GREATER LONDON AUTHORITY

Deadline 3 - Sheet 4: GLA commentary on other documents prepared by the Applicant for Deadline 2

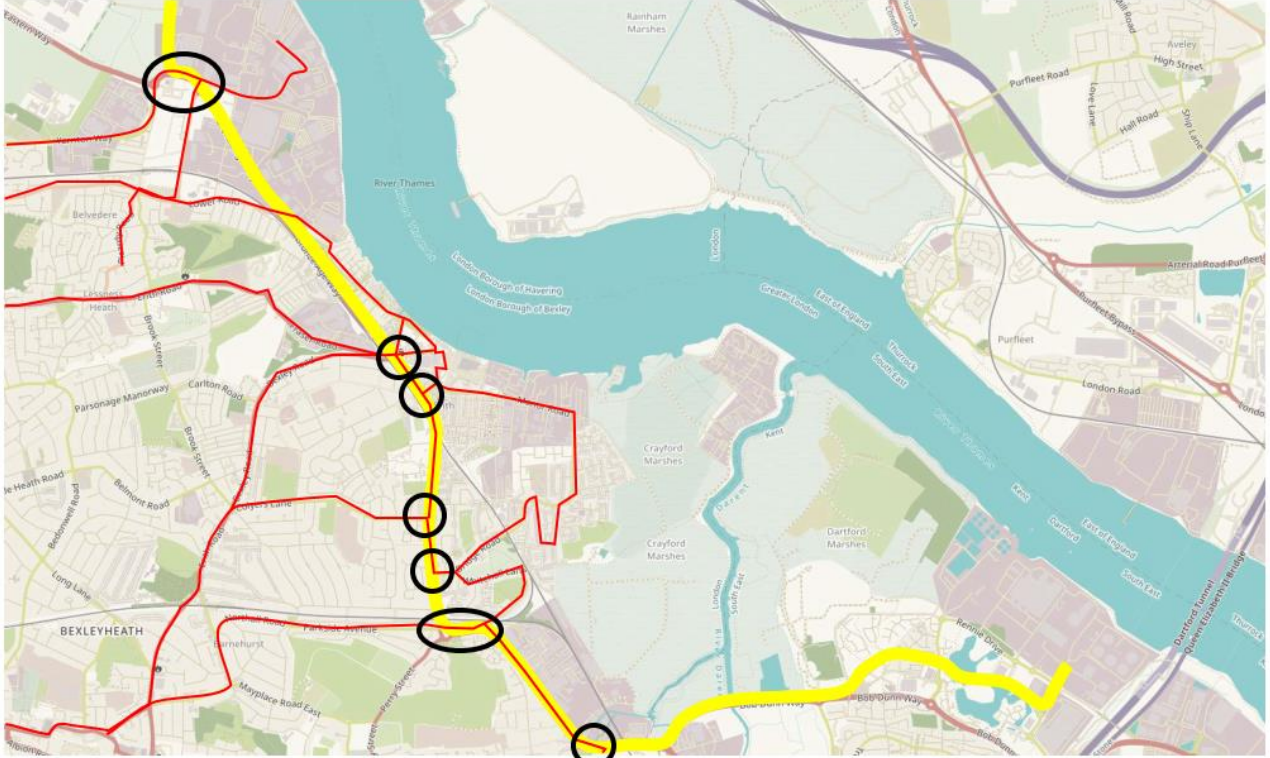
Item	Issue / action	GLA/TFL response
		 <p>The graph plots the residual waste treatment capacity gap in Mt on the y-axis (ranging from -10 to 20) against years from 2015 to 2030 on the x-axis. Four scenarios are shown: 'Gap at high growth, 50% recycling' (top dashed line), 'Gap at 55% recycling' (middle dashed line), 'Gap at 60% recycling' (solid line), and 'Gap at low growth, 65% recycling' (bottom dashed line). All scenarios show a decreasing gap over time, with the 60% recycling scenario reaching zero by 2025.</p> <p>(CIWM Presidential Report 2018: RDF Trading in a Modern World, page 37⁸)</p>

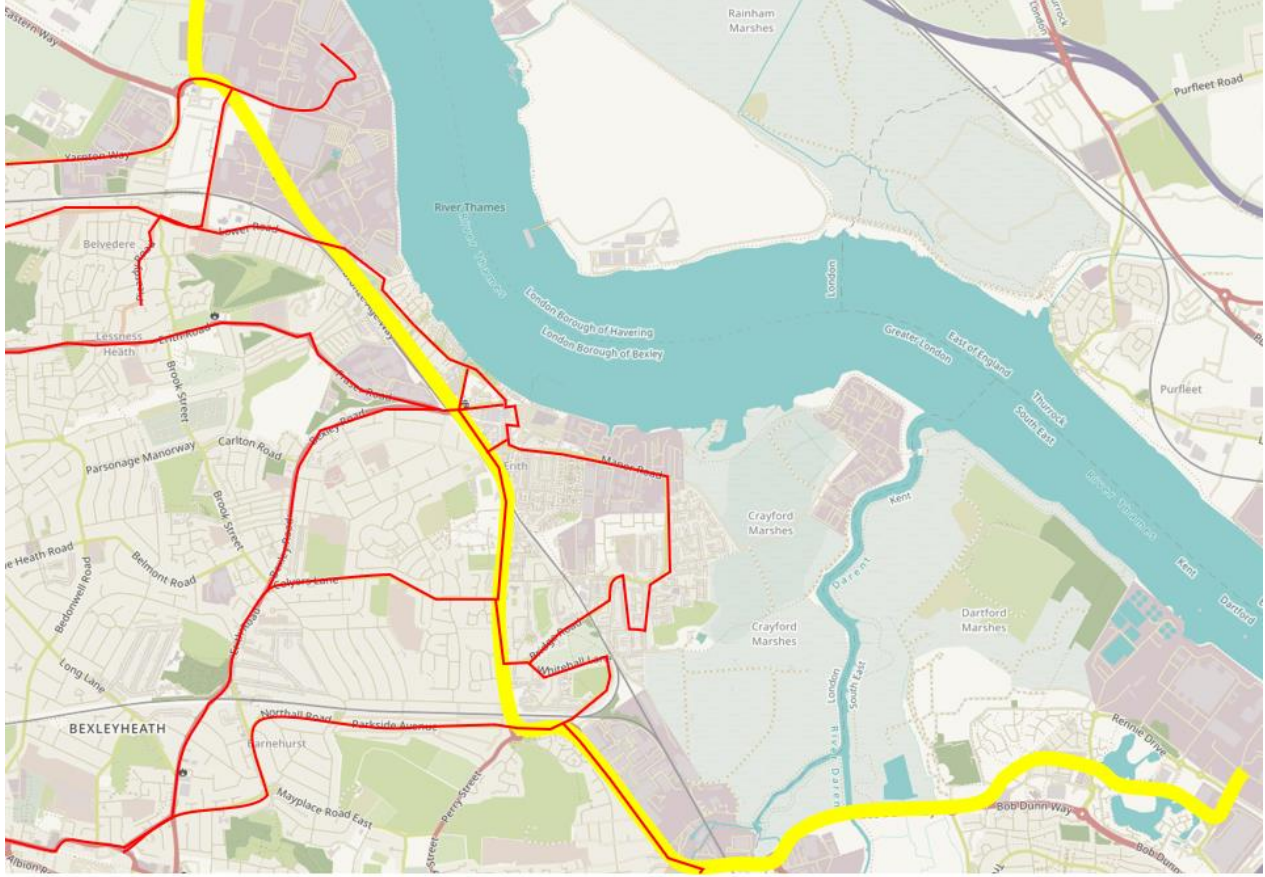
New measures re Electrical Connection	Additional commitment to assessment of bus delays to be proposed by the Applicant.	<p>In Technical Notes submitted at Deadline 2, the Applicant recognises the likely impact of the Electrical Connection construction on the operation of Erith Roundabout. To mitigate this, the Applicant proposes specific routing/construction around Erith roundabout to reduce impact of construction. For example; the applicant commits to avoiding the use of the northbound arm of the Erith Roundabout for Electrical Connection construction, however they may still need to close the eastern arm, which could cause delays at the junction due to displaced traffic onto the other arms, which would cause delays to road users, including buses. Quantifying of the time delay by the Applicant would allow TfL to consider the extent of required diversions for buses or increased frequencies to mitigate these delays. Furthermore, TfL consider that the impact of the Electrical Connection construction will not only impact on Erith Roundabout and the James Watt Way junction, but is likely to affect all main junctions along its route if arm/road closures are required, which the Applicant has not ruled out at this time. These junctions are shown in the figure below:</p>

Item	Issue / action	GLA/TFL response
		 <p data-bbox="757 1153 1019 1209"> █ ELECTRICAL CONNECTION █ BUS ROUTES </p> <p data-bbox="1265 1153 1944 1201"> EXPECTED PINCHPOINTS/ISSUE AREAS WHERE ELECTRICAL CONNECTION COULD CAUSE MAJOR DISRUPTION TO BUSES </p> <p data-bbox="734 1246 1966 1385"> Modelling of the junctions along the electrical connection route as highlighted in the figure above may be required if an alternative realistic method of assessing bus delays cannot be produced by the applicant. Modelling of construction impacts by applicants is standard practice for large development which would likely have an effect on the operation of bus services. This was done for </p>
